**Re: FortisBC Energy Inc. (FEI)**

**Application for a Certificate of Public Convenience and Necessity for the Inland Gas Upgrade Project (the Application)**

**Response to the British Columbia Utilities Commission (BCUC) Information Request (IR) No. 1**

**BC Forest Products Lateral Demand and Capacity Graph**

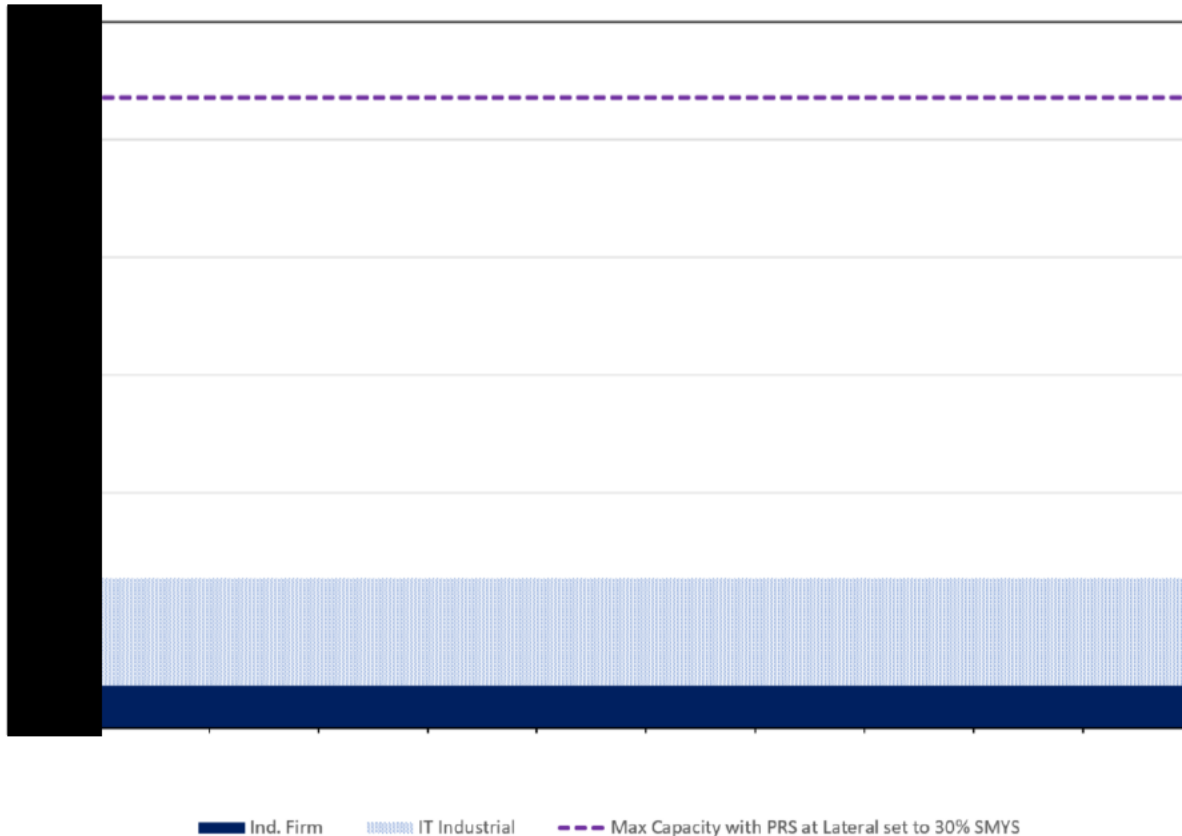
14.3 For each of the 29 laterals, please provide graphs of pipeline capacity (at current and reduced pressure) and the historical and the 20 year forecasted peak demand of: (i) firm customers; (ii) interruptible customers; and (iii) new customers.

- 3
- 4 The BC Forest Products Lateral is a component of the MacKenzie System downstream of the
- 5 MacKenzie Lateral 168 and Loop 168. The graph above illustrates that a PRS installed at the

- 6 start of the lateral has capacity well above the requirements of the industrial customers served by
- 7 the lateral. The pressure at the start of the lateral varies relative to the total MacKenzie System
